FACILITY: Hope Creek Generating Station

SUBJECT: SUMMARY OF JUNE 28, 1984 HYDROLOGY MEETING

APPLICANT: Public Service Electric & Gas Company (PSE&G)  
FACILITY: Hope Creek Generating Station  
SUBJECT: SUMMARY OF JUNE 28, 1984 HYDROLOGY MEETING

FIGURE 3.4-4

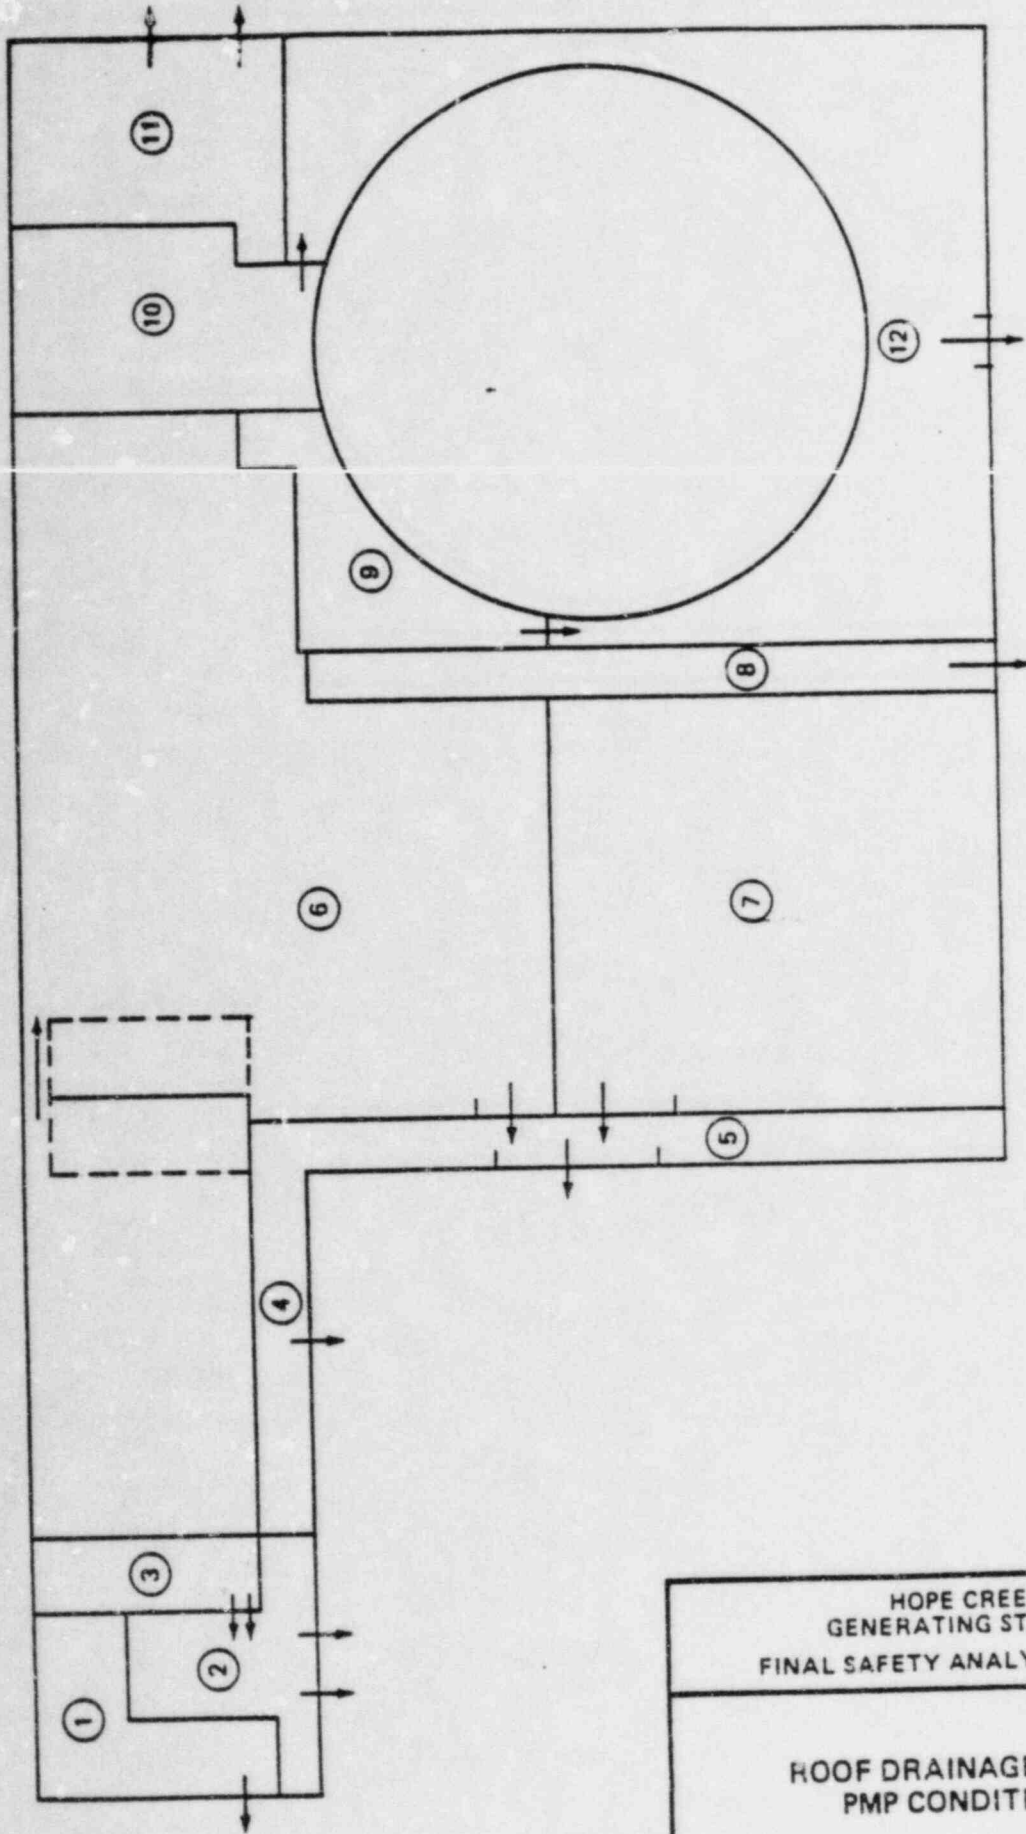
Provide your detailed analysis of the PMP ponding levels on roofs of safety-related structures requested in Q240.7. Details should identify and provide information on the roof area of each sub-drainage area for each safety-related structure; the size, number and distance above roof (elevation) of the invert of each scupper (overflow drain) for each drainage system, and the elevation of the curb of each roof hatch within each roof drainage area system. Also provide details used to conclude that the ponding resulting from PMP does not effect safety-related facilities.

The roof drainage system consists of roof drains and 6-inch diameter scuppers located 6 inches above the roof drain elevations. Supplementing the roof drain system is a series of openings in the parapets of the roofs of the buildings. The 6-hour, local, all-season PMP was used to size these openings. The PMP, which is 27.5 inches, is distributed into 5-minute increments such that the maximum amounts for durations of 1 hour, 30 minutes, 15 minutes and 5 minutes are 18.1, 13.7, 9.5 and 6 inches respectively. Roof elevations, sub-drainage areas, and the dimension of parapet openings are shown in Table 3.4-3. A schematic of the roof drainage is shown on Figure 3.4-4.

The routing of the PMP assumes no losses, the roof drain system to be non-functional, and the ponding is allowed up to the limiting elevation of the top of the curb of each roof drain within each roof drainage area system. Prior to the PMP, an initial level of ponding at the invert elevation of the parapet openings is assumed (invert elevation is 6 inches above the roof drain elevation).

Since the limiting water depths are greater than the ponding levels resulting from the PMP (as shown in Table 3.4-3), the ponding levels do not effect safety-related facilities.
